**STAFF RECOMMENDATION**  
**1701 Woodland Street**  
**January 18, 2012**

**Application:** New construction—appeal of staff decision, accessory structure, and setback reductions

**District:** Lockeland Springs-East End Neighborhood Conservation Zoning Overlay

## SITE PLAN

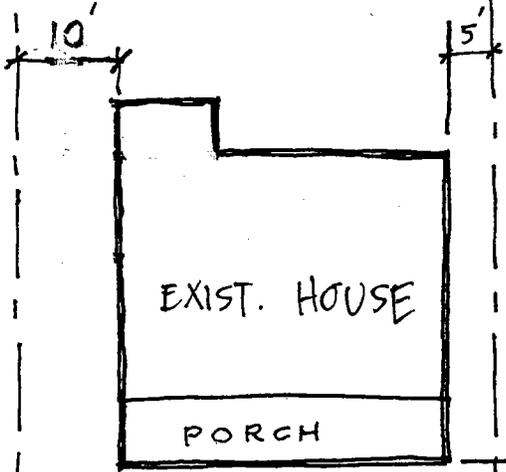
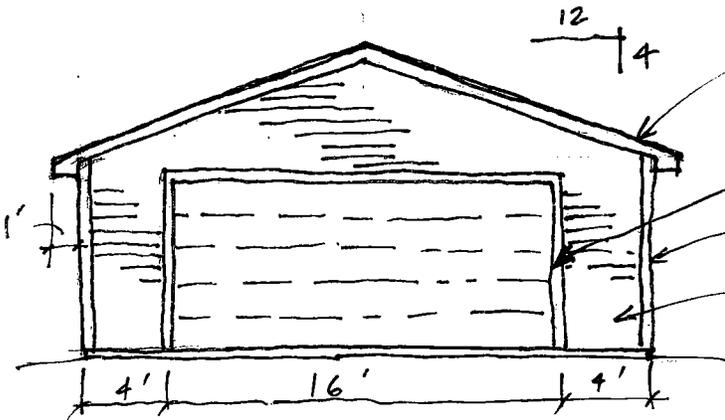
New carport addition to garage. Minimum setback of 10' on rear and side required.
